Access Compliance Report

Public Rights-of-Way

(Curb Ramps)

Intersection ID: 11839	Main Street: FLEETWOOD_DR	Cross Street: EVERGREEN_DR	Location: SE
ADA ID: B25F80192077	Ramp Type: Perp	Initial Pass/Fail: Fail	Overall Compliance: No
		Severity Score: 10

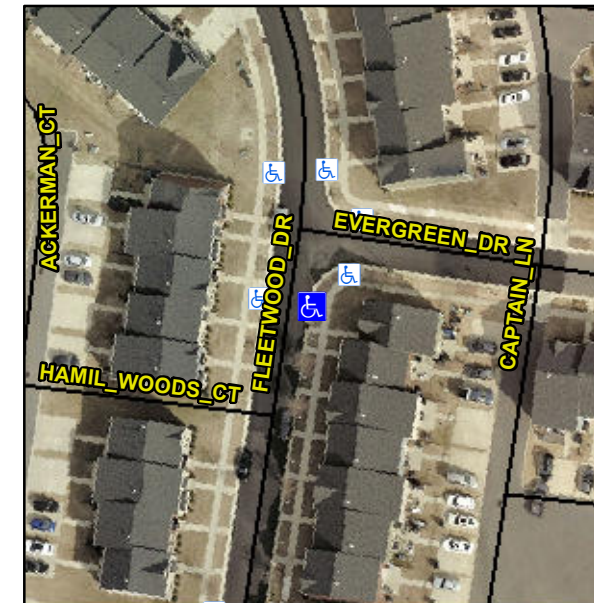
Not Found, R304.5.1

Compliance	Description	Data	Compliance	Description	Data
N/A	Ramp Length (in)	77.0	Yes	Ramp Slope (%)	6.9
No	Ramp Width (in)	47.0	Yes	Ramp XSlope (%)	3.5
N/A	Flare Type LT	N/A	N/A	Flare Type RT	N/A
N/A	Flare Slope LT (%)	N/A	N/A	Flare Slope RT (%)	N/A
N/A	Flare Traversable LT?	N/A	N/A	Flare Traversable RT?	N/A
N/A	Landing Length (in)	N/A	N/A	DWS Provided?	N/A
N/A	Landing Width (in)	N/A	N/A	DWS Contrast?	N/A
N/A	Landing Slope (%)	N/A	N/A	DWS Length (in)	N/A
N/A	Landing X Slope (%)	N/A	N/A	DWS Full Width?	N/A
N/A	Landing Curb? (Y/N)	N/A	N/A	DWS Offset (in)	N/A
N/A	Shared Landing?	N/A			
N/A	Gutter Ponding?	N/A	N/A	Gutter Slope (%)	N/A
N/A	Gutter Lip Ht (in)	N/A	N/A	Gutter X Slope (%)	N/A
N/A	Painted X Walk1?	No	N/A	Painted X Walk2?	N/A
	X Walk 1 Direction	To W		X Walk 2 Direction	N/A
N/A	X Walk 1 Width (in)	N/A	N/A	X Walk 2 Width (in)	N/A
	X Walk 1 Slope (%)	3.9		X Walk 2 Slope (%)	N/A
	X Walk 1 X Slope (%)	5.0		X Walk 2 X Slope (%)	N/A

Remove & Replace Entire Ramp.
